Process Sheet

: SADDLE, OUTBOARD, LH, 206

DART AEROSPACE LTD	Work Order:	28601
Description: 206 Saddle, Outboard, Left side	Part Number:	D2665-1
Inspection Dwg: D2665 Rev. C		Page 1 of 1

Subject: RE: D2665 Saddle

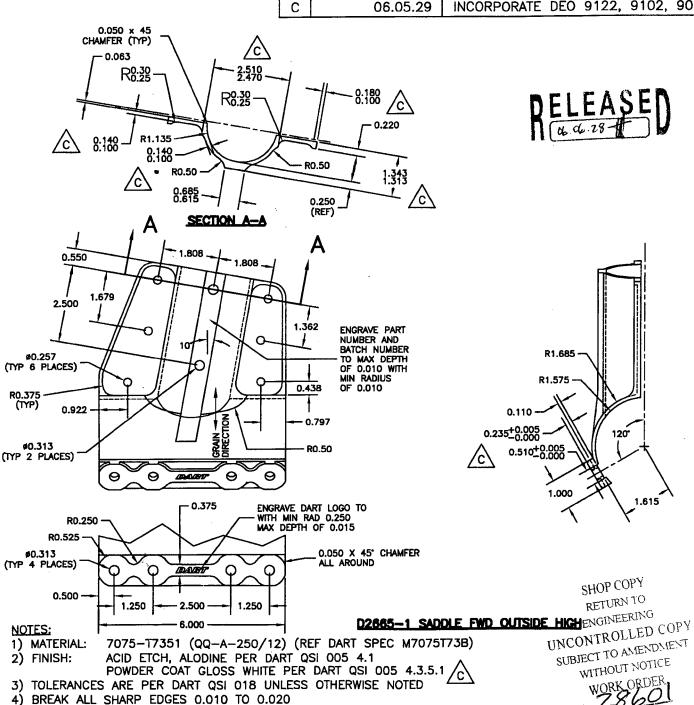
The two 0.313 OD saddle-to-crosstube holes, the dwg says 0.313, the folio is evidently calling for a 0.316 drill. The 0.316 is required to fit the part on the tooling, they must have been using 0.316 for some time. Anyhow, they want the drawing changed to 0.316 (I don't see a big problem with that), but for now they need an email to sign of this latest batch as a deviation on the work order. Ultimately this would affect all the 206 saddles. Is 0.316 OD acceptable for the saddle-to-crosstube holes on the D2665 saddles?

W/O:			WORK ORDER CHANGES							
DATE	STEP	PROCEDURE		Ву	Date	Qty	Approval Chief Eng / Prod Mgr	Approval QC Inspector		
selsa/21		-dimension S should be Rango - on FAT should -a new 60-NO 60 gauge and s	d to .316 on drawing De .316 min and .321 max T# should be made attached DS email	J.L	06/09/21		06.09.2) per QSI 647

This is acceptable.
